BOARD OF APPEALS
Thursday, July 2, 2020
6:00 PM

Appeal: Requesting variances from Section 58-236(i), 58-236 (g)(2), 58-236(c)(1)(d), and 58-418(d) of the Mequon Code of Ordinances in order to decrease the setback from the front property line from 82 feet to 80.9 feet, increase the height of an accessory structure from 15 feet to 22 feet, and keep the existing accessory structure in addition to the new detached garage at 3207 W. Donges Bay Road.

Appeal from Denial of Building Permit
 3207 W. Donges Bay Rd.

sheet number
1 of 10

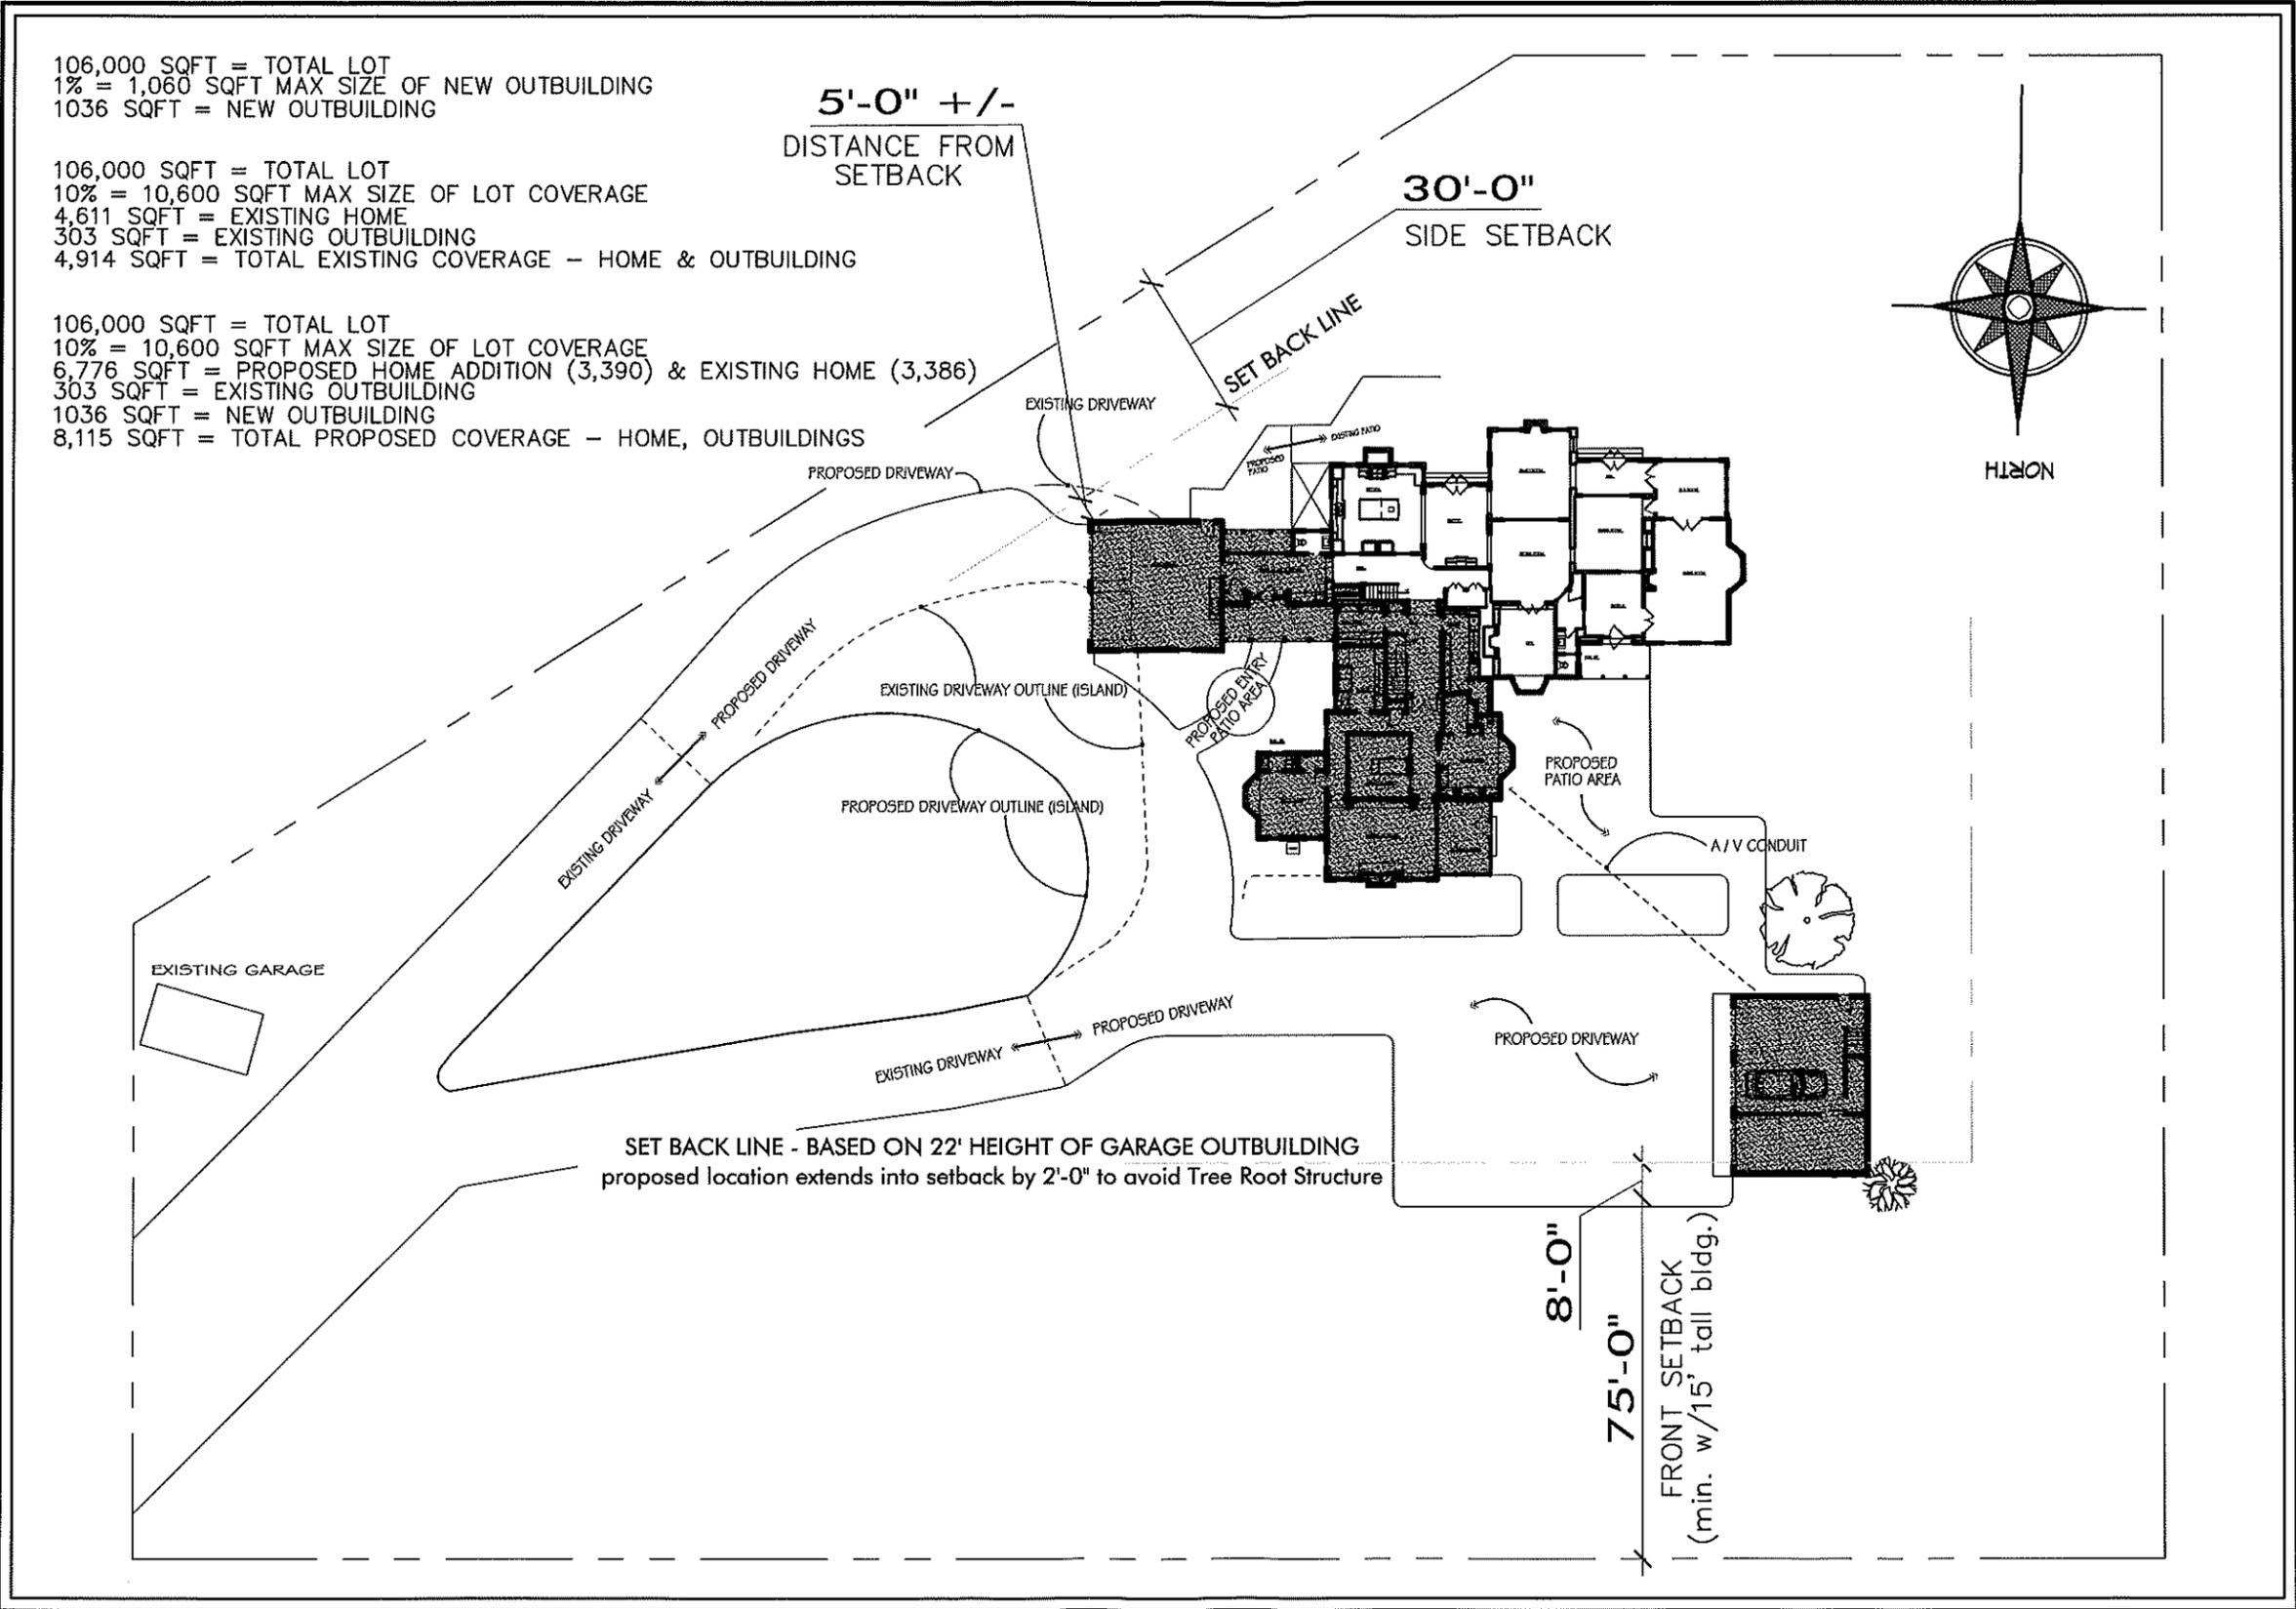
Based on these code sections, the proposed garage which is shown at 22 feet in height is required to be setback 82 feet from the front property line. The plan shows the proposed building at 80.9 feet. In addition, the existing structure would need to be razed prior to issuance of a building permit.

Based on the proposed height of the structure, the setback from the Donges Bay right of way is 82 feet. Based on the plan submitted, the structure is shown to be located 80.9 feet from the property line. The applicant states that the variance is justified based on two conditions unique to the property. First, the applicant claims the city right of way extends deeper into the property than normally would be the case. He references correspondence with the City Forester, Mike Gies as evidence of this situation. Second, the applicant states that the reason for the variance of 14" is based on lessening impact on two existing trees that are located in the area of the proposed structure.

While the request to deviate from the front setback seems relatively innocuous, staff does not believe the applicant provides rationale for being granted a variance. An approval of the variances could set a precedent for further instances where requests for minor unsubstantiated code deviations could appear in front of the Board. With regard to the removal of the detached garage, the applicant does not provide any justification that is not self-created or economic in nature to why the variance should be granted and accordingly recommends denial.

sheet number
5 of 10

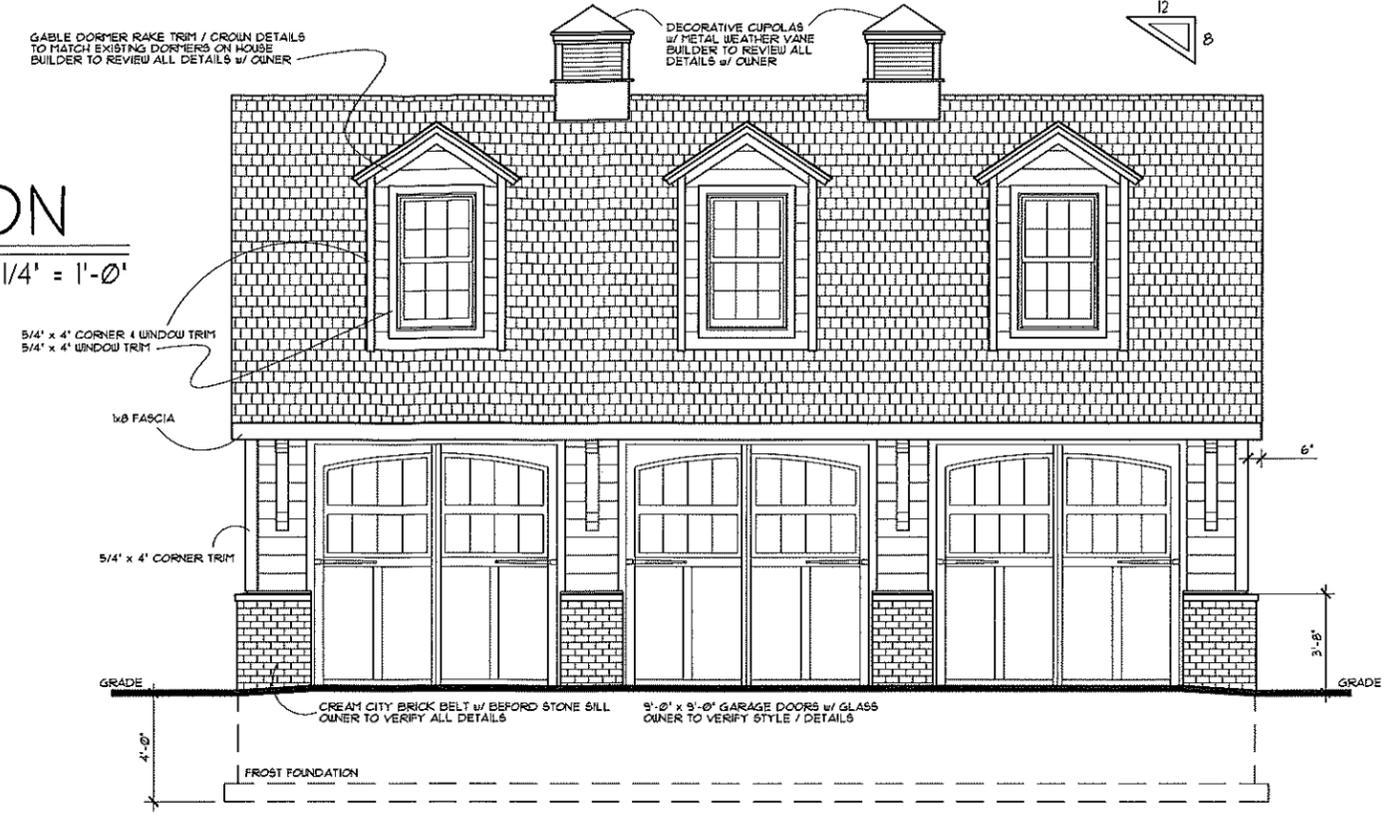
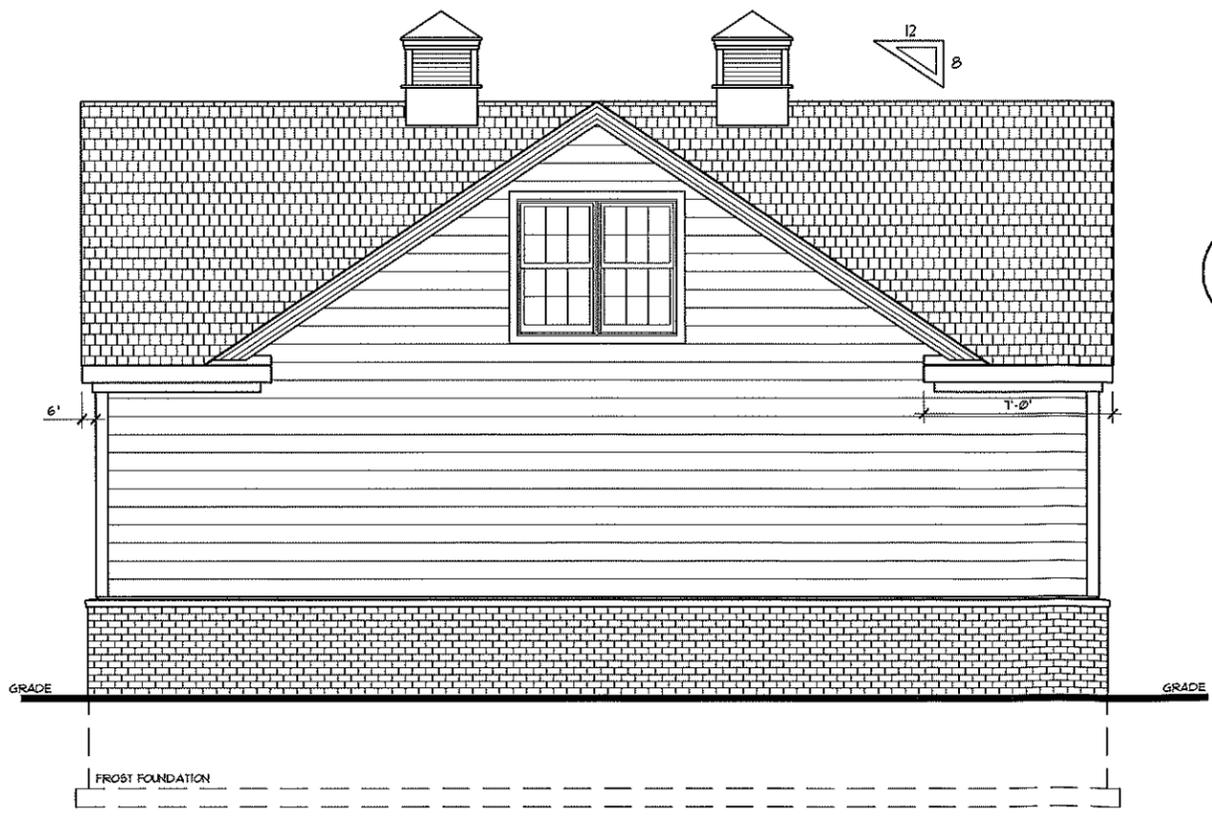
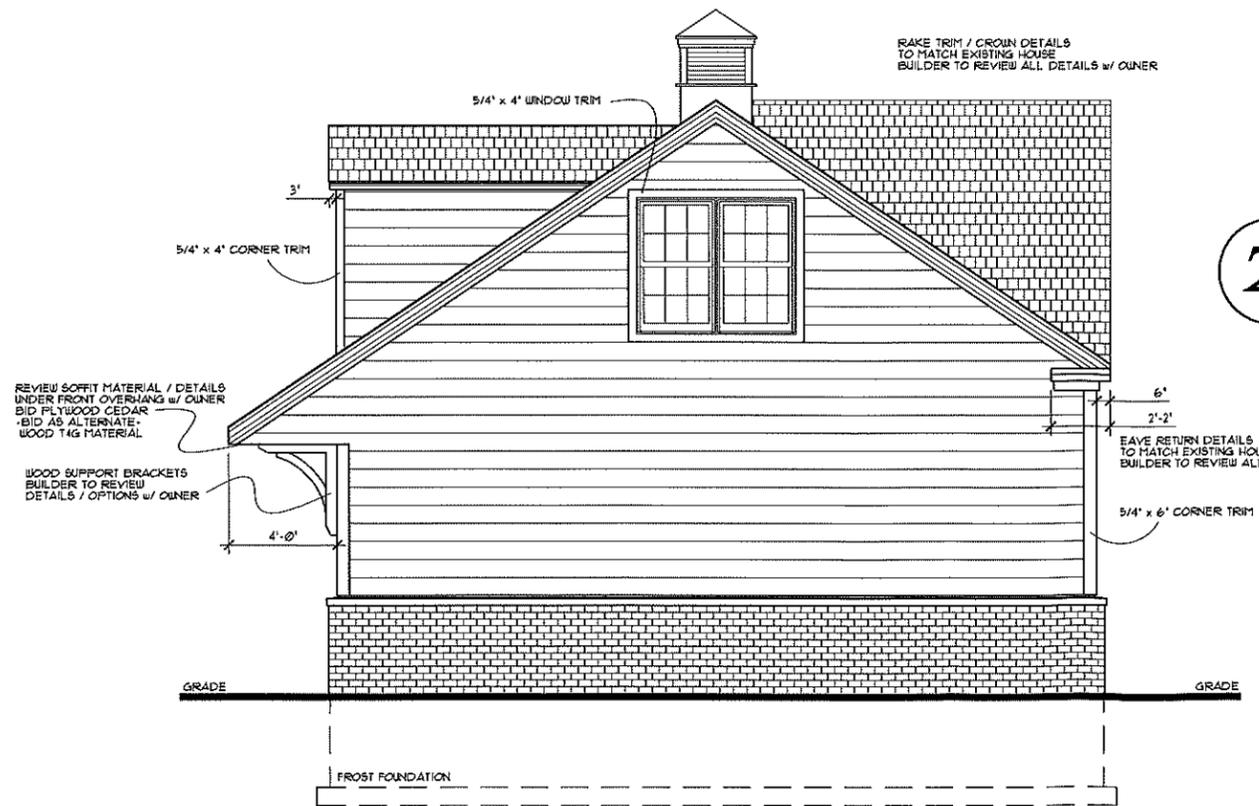
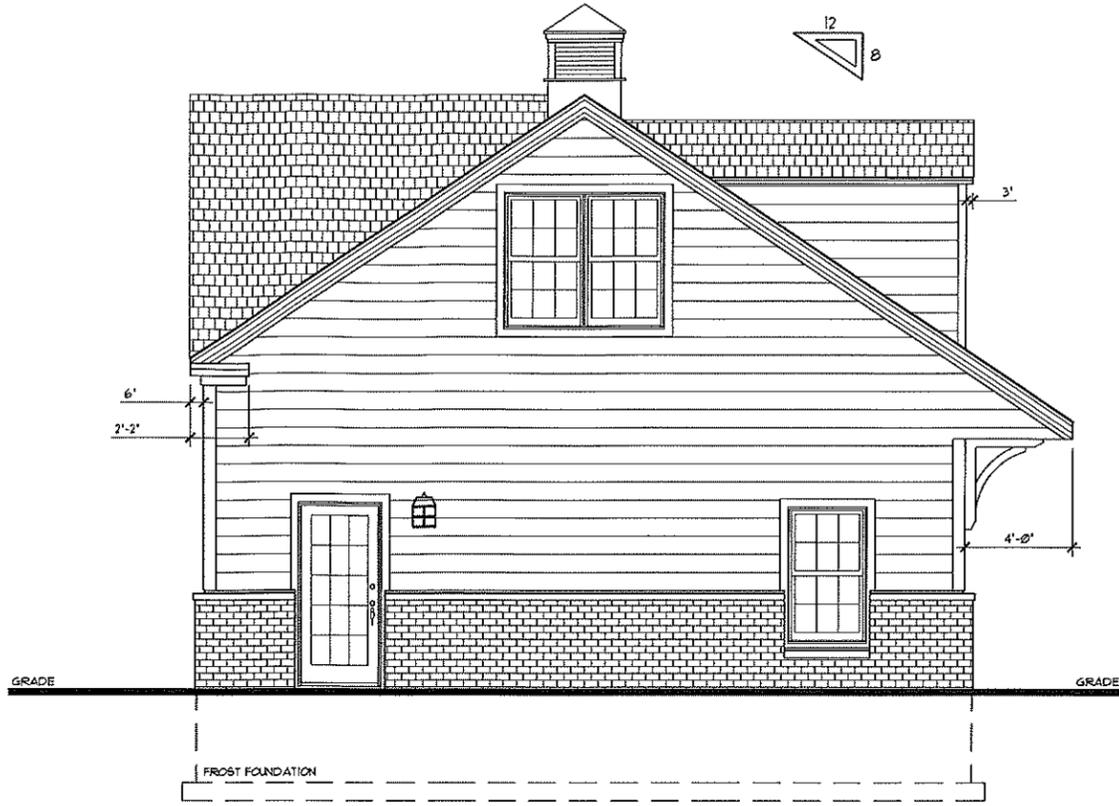
the building or a combination of both. The plan shows 10'6" walls for the first floor and 7'1" ceiling clearance on the second floor. The plan also shows 2'6" returns on each end of the garage wall. A slight modification to all or some of these elements could bring the plan into compliance without impacting the design of the building or the trees. The desire to have a garage of this size and height is self-created and contrary to the criteria needed to approve the variance.
